Access Compliance Report Public Rights-of-Way (Curb Ramps)

Main Street: WELDON_HEIGHTS		Cross Street: BENNINGTON_PATH		Location:	SE
ADA ID: RPAT211104130940	Ramp Type: Type 4 - Parallel	Initial Pass/Fail: Fail	Overall Compliance: No	Severity Score:	16
Codes/Mitigation Info/Possible Solution			Field Measurements/Component Compliance

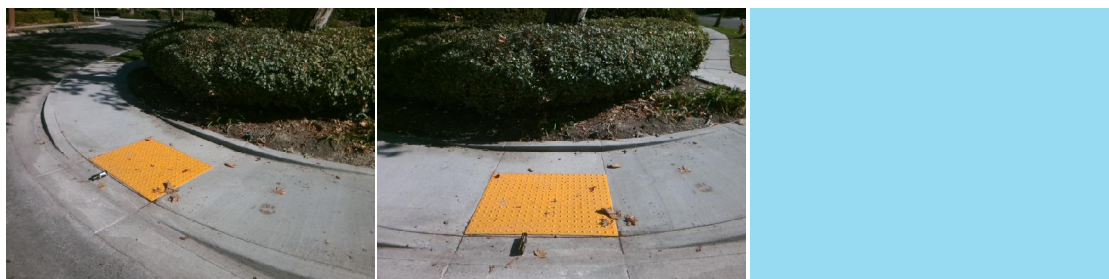
Compliance	Description	Data	Compliance	Description	Data
N/A	Ramp Length LT (in)	84	N/A	Ramp Length RT (in)	78
Yes	Ramp Width LT (in)	58	Yes	Ramp Width RT (in)	58
Yes	Ramp Run Slope LT (%)	2.7	No	Ramp Run Slope RT (%)	9.6
No	Ramp Cross Slope LT (%)	2.7	Yes	Ramp Cross Slope RT (%)	1.6
N/A	Landing Present	N/A	N/A	DWS Provided	N/A
N/A	Landing Length (in)	N/A	N/A	DWS Contrast	N/A
N/A	Landing Width (in)	N/A	N/A	DWS Length (in)	N/A
N/A	Landing Run Slope (%)	N/A	N/A	DWS Full Width	N/A
N/A	Landing Cross Slope (%)	N/A		DWS Offset Type	N/A
N/A	Landing Movement Obstructed?	N/A	N/A	DWS Offset Left (in)	N/A
	Landing Movement Type	N/A	N/A	DWS Offset Right (in)	N/A
N/A	Landing Shared	N/A			
N/A	Clear Space	Yes			
N/A	Clear Space To Crosswalk (in)	N/A			
N/A	Marked Crosswalk 1	No	N/A	Marked Crosswalk 2	No
	Crossing 1 Direction	N		Crossing 2 Direction	W
	Marked Crosswalk 1 Width (in)	N/A		Marked Crosswalk 2 Width (in)	N/A
N/A	Ramp Inside Crosswalk 1	N/A	N/A	Ramp Inside Crosswalk 2	N/A

Remove & Replace Curb Ramp With Two New Directional Ramps or Equivalent.
